## WHITEMARSH TOWNSHIP PLANNING COMMISSION

**WHITEMARSH TOWNSHIP  
PLANNING COMMISSION MEETING AGENDA (REVISED)  
March 22, 2022  
7:00 PM**

- Review SLD #01-22 – 931 Spring Mill Avenue, LLC (“Westy Project”) / 927-931 Spring Mill Avenue, Conshohocken; Major Land Development Plan Review for 3-story, 20-unit Apartment Building

BORKOWSKI HOMES PRESENTS WESTY PROJECT

**TITLE**  
EXISTING CONDITIONS PLAN

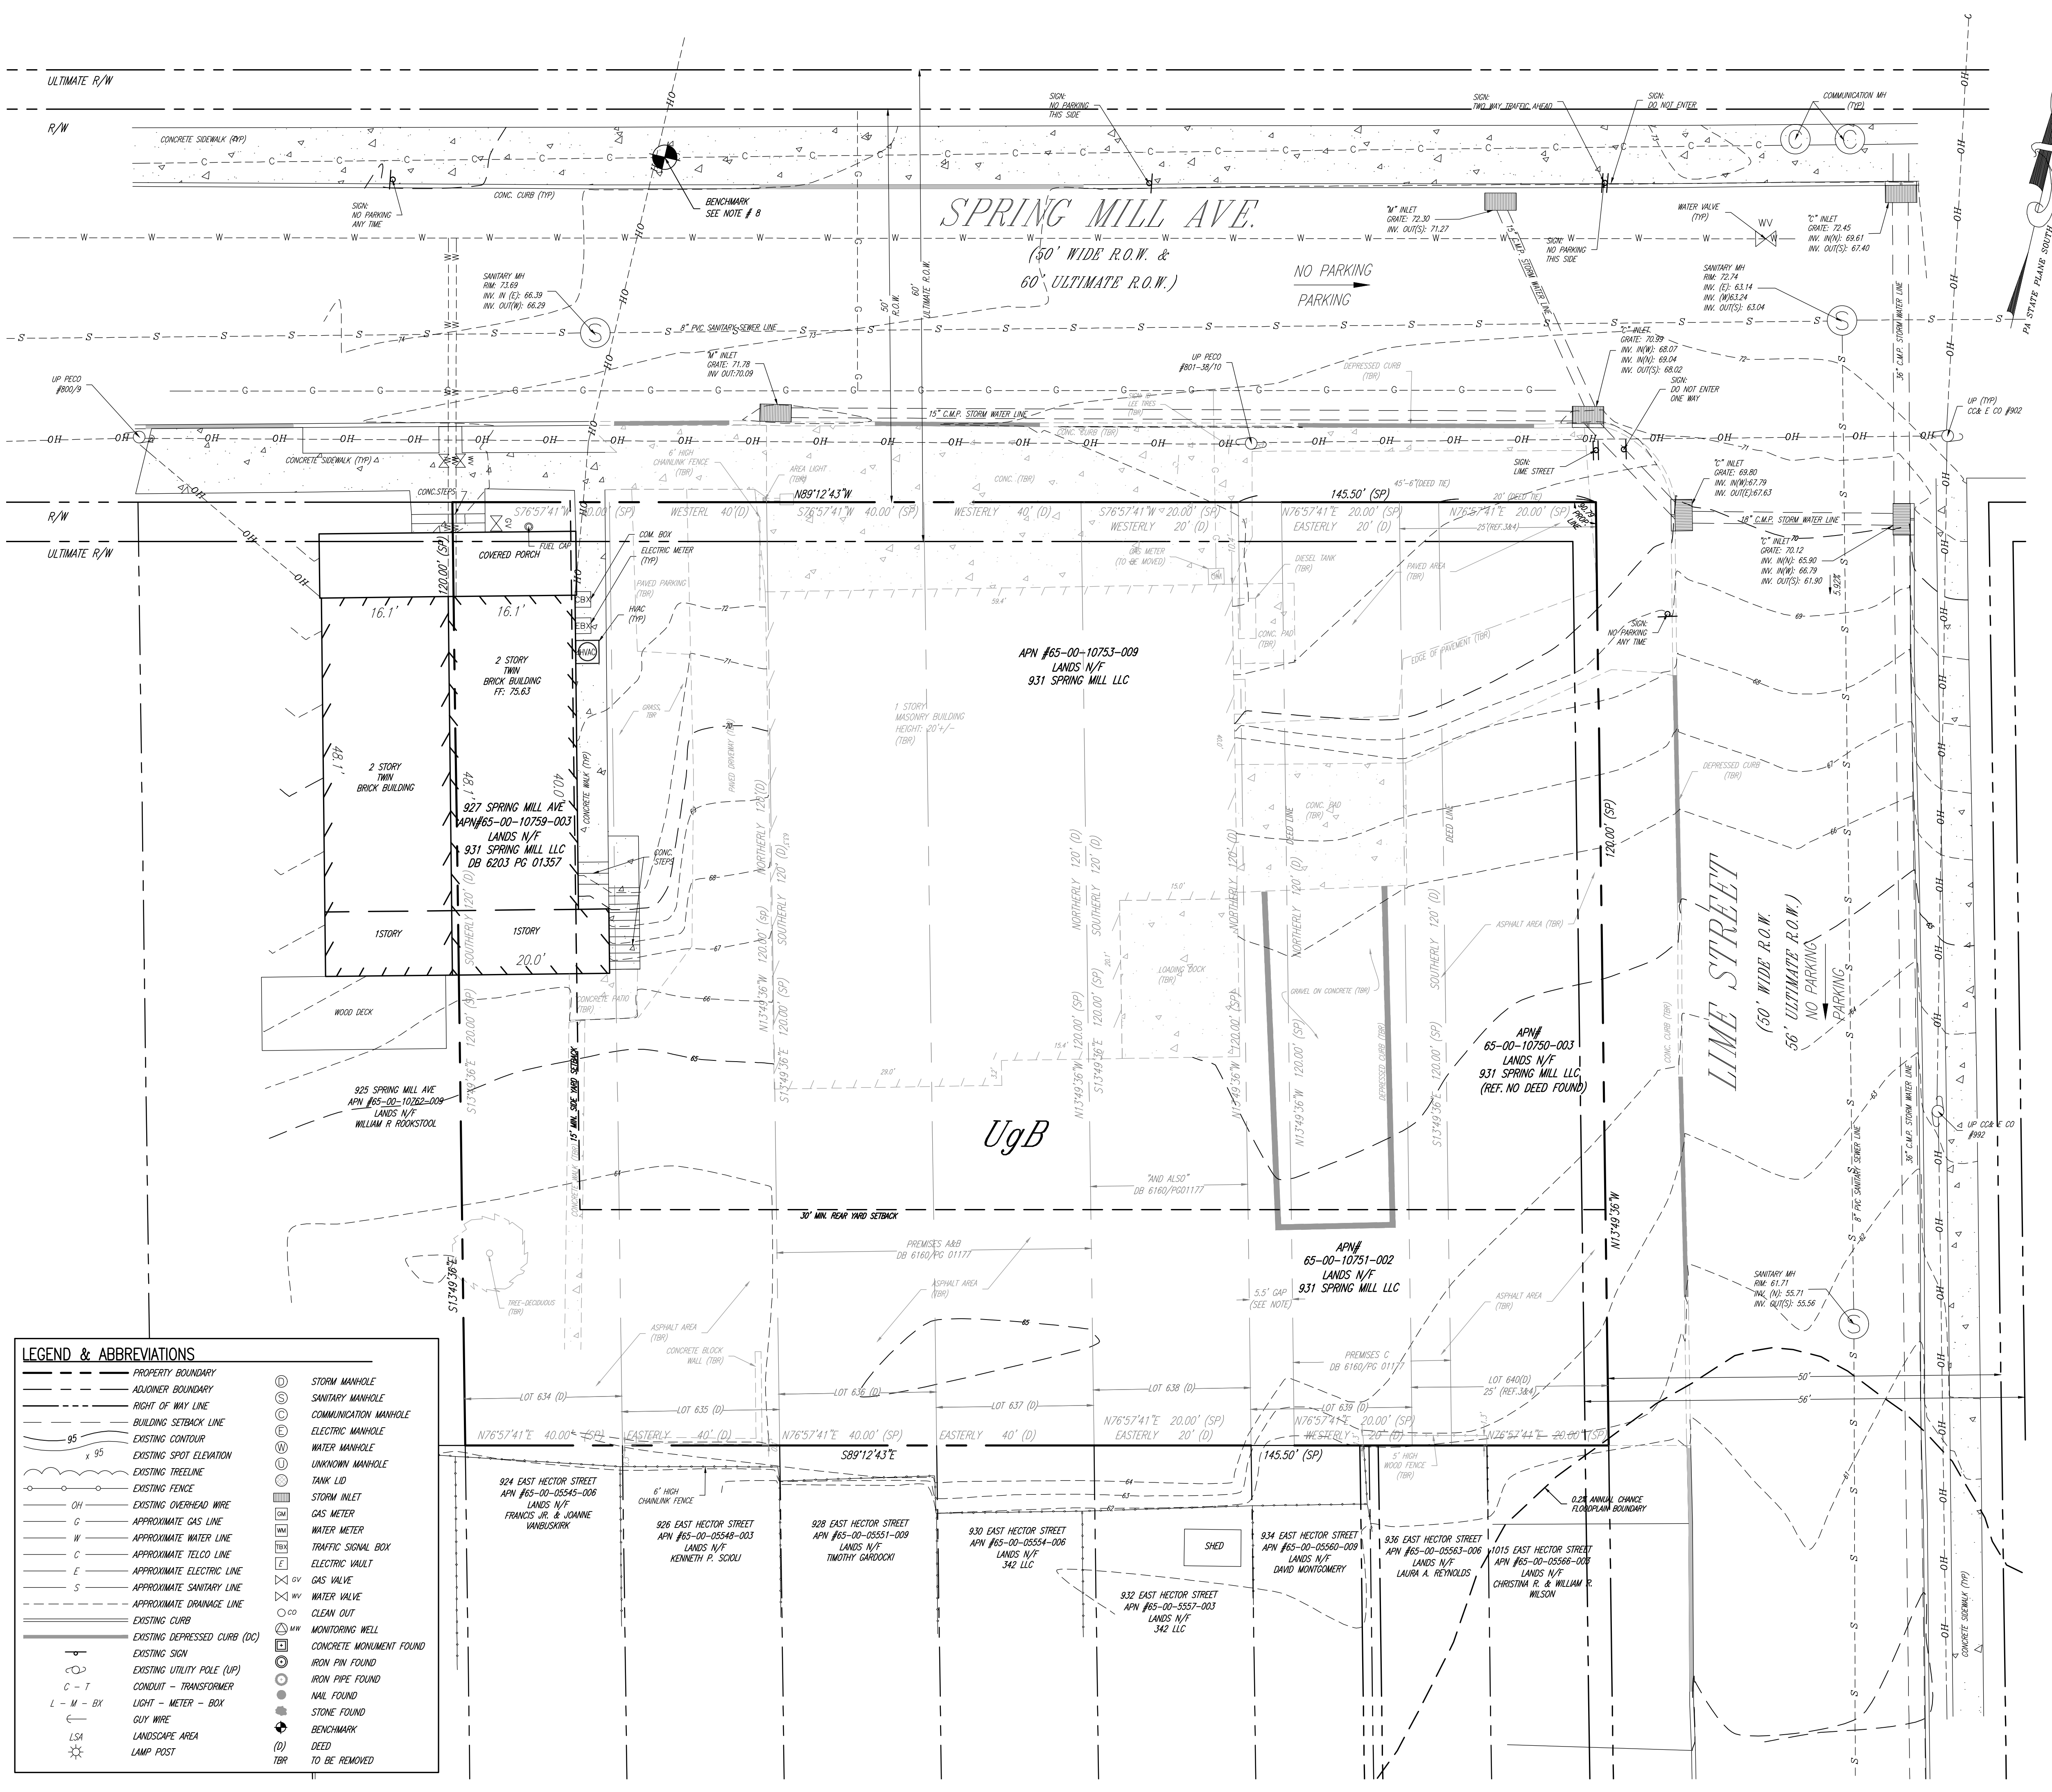
2.	105-21(B)(1) (e)[6]	The plans must be revised to provide an indication of the size of units (in bedrooms), if known.
3.	105-21(B)(1) (e)[6]	Sheet C02.1 must be revised to show boundaries of all adjoining properties, including names of landowners across Spring Mill Avenue and Lime Street.

#### *a. Functionality of the sub-surface parking arrangement.*

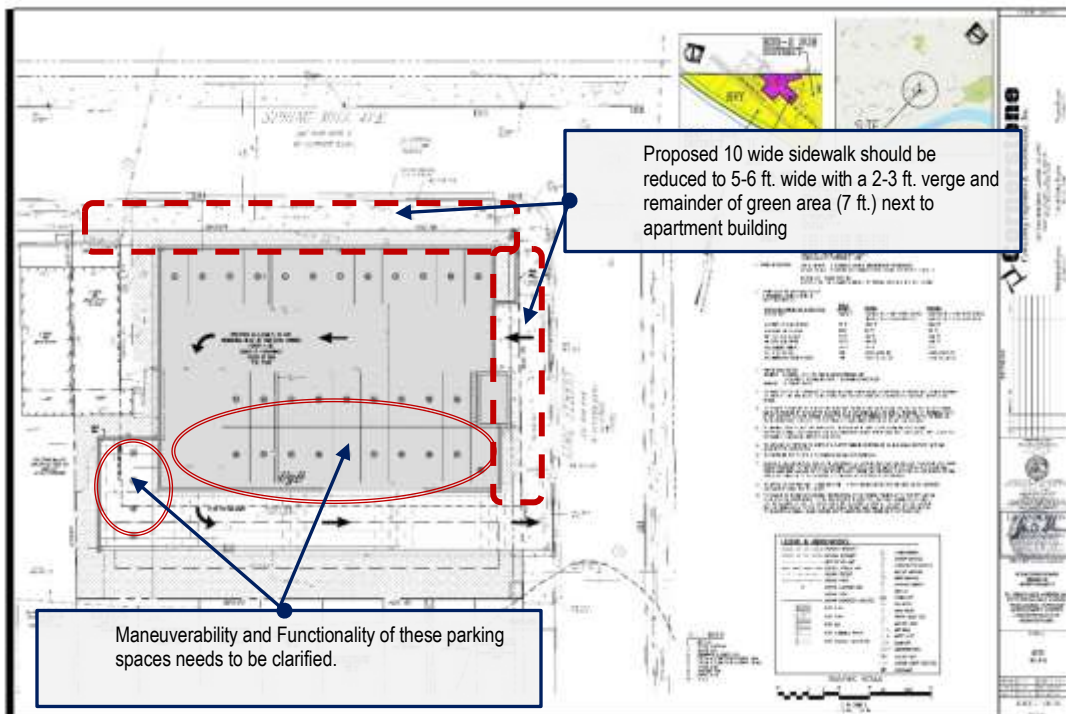
The plan proposes a number of parking spaces in which the functionality and maneuverability of vehicular parking is questionable. The plan shows a number of parking spaces (shown as #26- #35) under the building and immediately adjacent to building’s exterior wall that appear to be double-stacked with the opposite parking spaces (#17-25), which would prevent access. It is not clear from the applicant’s submitted plans whether cars are designed to enter directly to these spaces (#26- #35) from the paved area along the property’s southern boundary. The applicant should clarify how these spaces are designed to function effectively and safely, and we recommend the applicant provide the township with an architectural elevation of the south façade. Also, several parking spaces, (#1-#4) shown outside the sub-surface structure and adjacent to a retaining wall appear to have a blind spot and limited viewing for drivers backing out into the drive aisle. The applicant should provide architectural and structural details on how these spaces will function. These issues are highlighted below in the annotated graphic.
